**TOWN OF NEWBURGH  
PLANNING BOARD  
TECHNICAL REVIEW COMMENTS**

**PROJECT: CUMBERLAND FARMS**  
**PROJECT NO.: 16-05**  
**PROJECT LOCATION: SECTION 86, BLOCK 1, LOT 14 & 15**  
**REVIEW DATE: 3 OCTOBER 2016**  
**MEETING DATE: 6 OCTOBER 2016**  
**PROJECT REPRESENTATIVE: BOHLER ENGINEERING**

**Re: Response to Comments Summary  
Proposed Cumberland Farms  
270 NY-17K  
Town of Newburgh, New York**

Re: Cumberland Farms Amended Site Plan  
Rock Cut Rd - County Route 23  
Town of Newburgh, SBL: 86-1-14 & 15  
Plans By Bohler Sheets Numbers 1-16 dated 1/12/16, Last Revised 5/3/16

## STABILIZED CONSTRUCTION EXIT

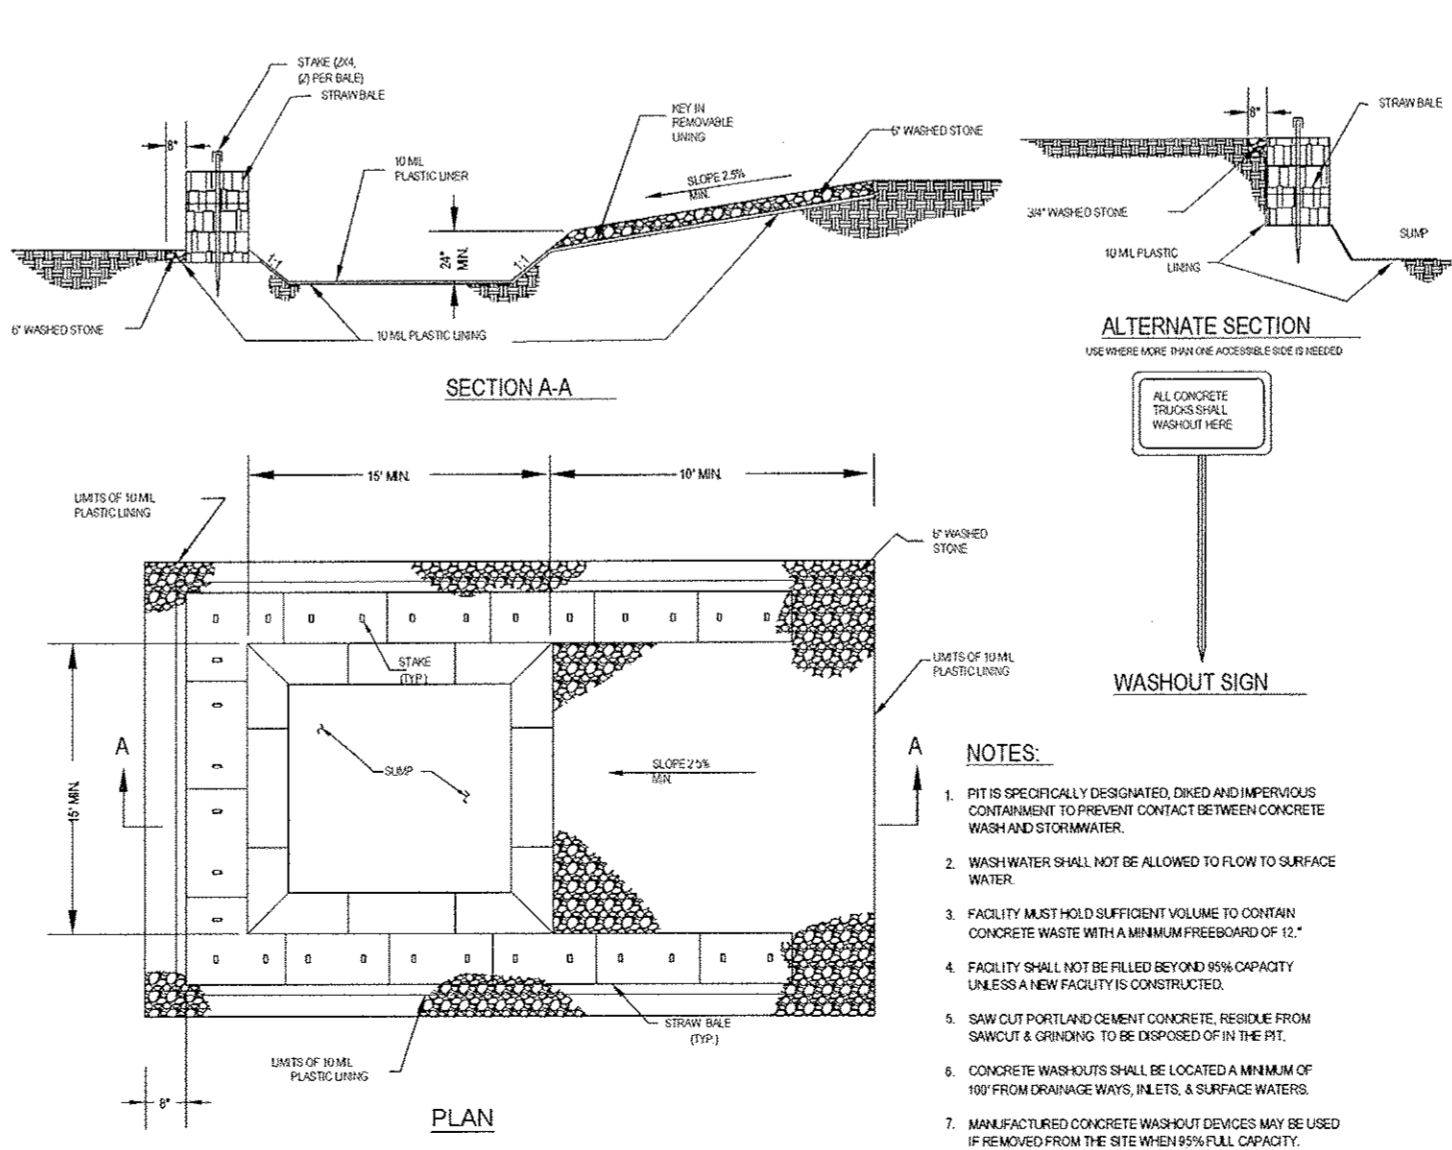
- Provide a stabilized Construction Entrance Detail. The stabilized entrance is required to be a minimum of 50 feet long by 12 feet wide and thickness of 12 inches thick.

SHEET TITLE:  
**UTILITY PLAN**

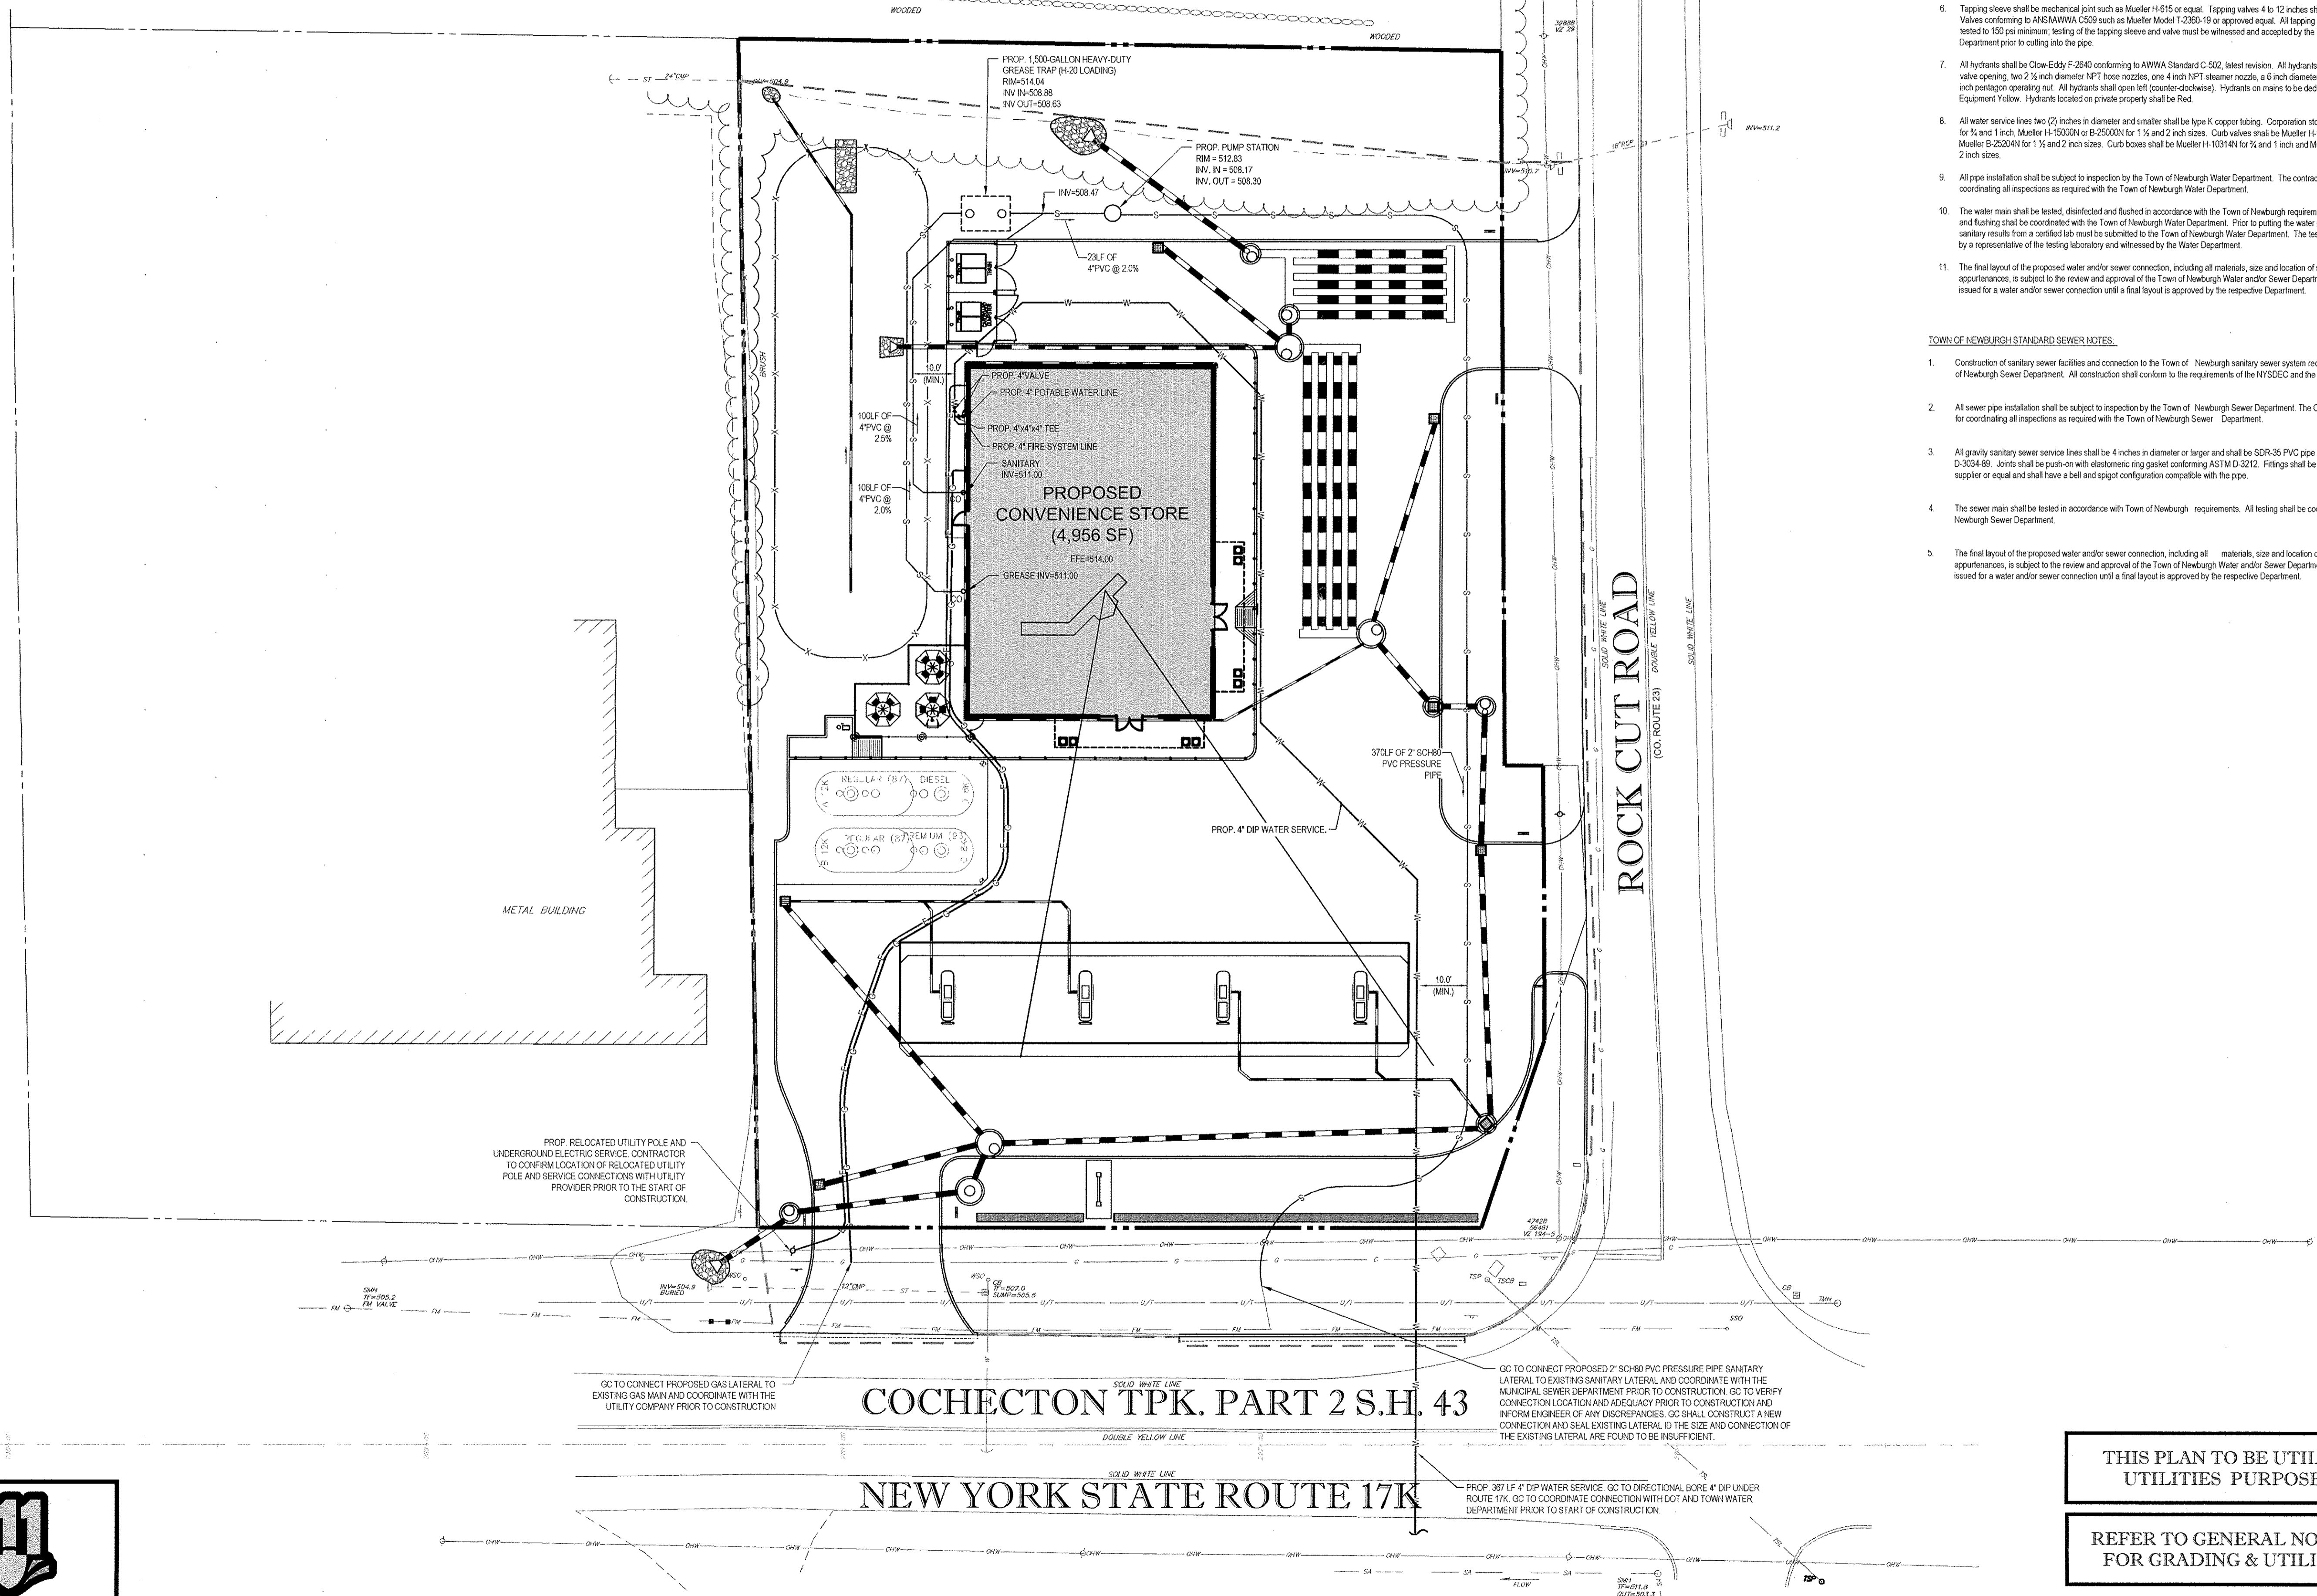
7. Water service lateral must be set up such that when sprinkler system is terminated potable water is terminating valving must be provided to incorporate that.  
*The proposed water service valves and service lines have been updated on the Utility Plan as requested.*

8. Water service lateral does not appear to meet separation distances from drainage pipe along rear of structure.  
*Water service lateral has been revised to meet separation distances from drainage pipe.*

**DRIVEWAY APRON DETAIL** N.T.S.

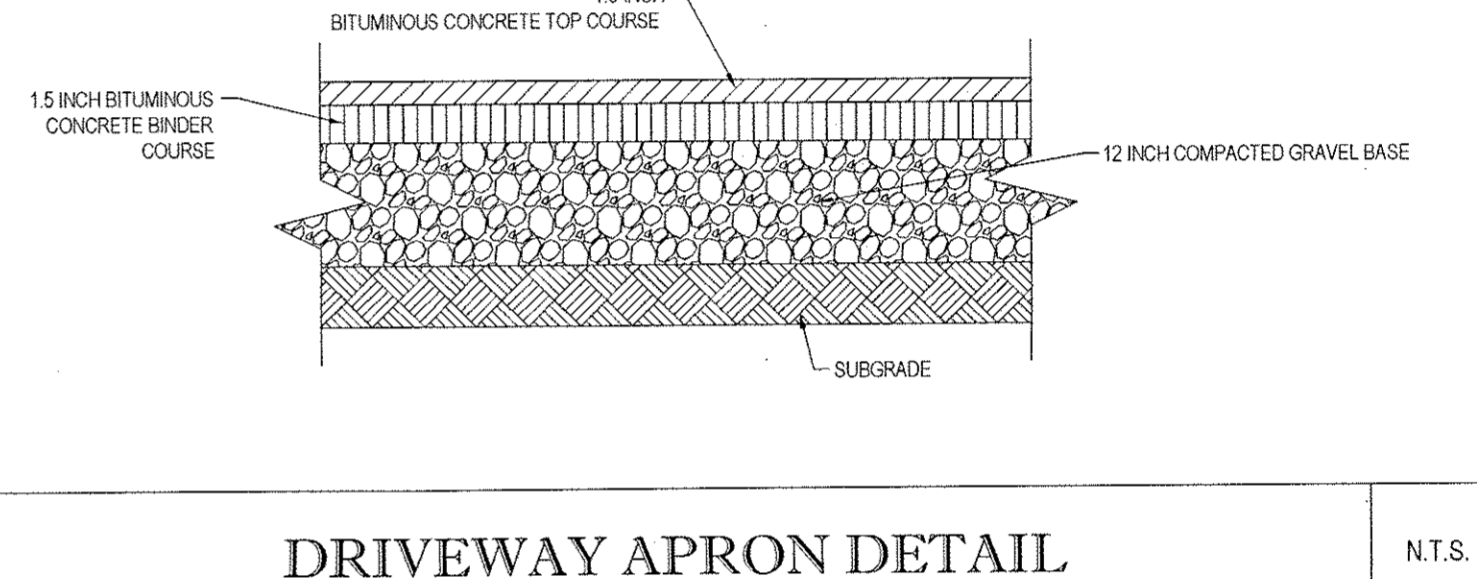
- The driveway apron of the Commercial entrance is required to be paved per Orange County Specifications for the first 50 feet from the edge of pavement. See the commercial entrance standard details in the policy and standards.
- The proposed radius of the commercial entrances per policy and standards is required to be 30 ft to 40ft. The 10 ft radius is not acceptable.
- Provide plan and profile specifying the Low Point and as it relates to the edge of pavement with dimensions. A minus -2% slope is required to from the edge of pavement for the first 20 feet.
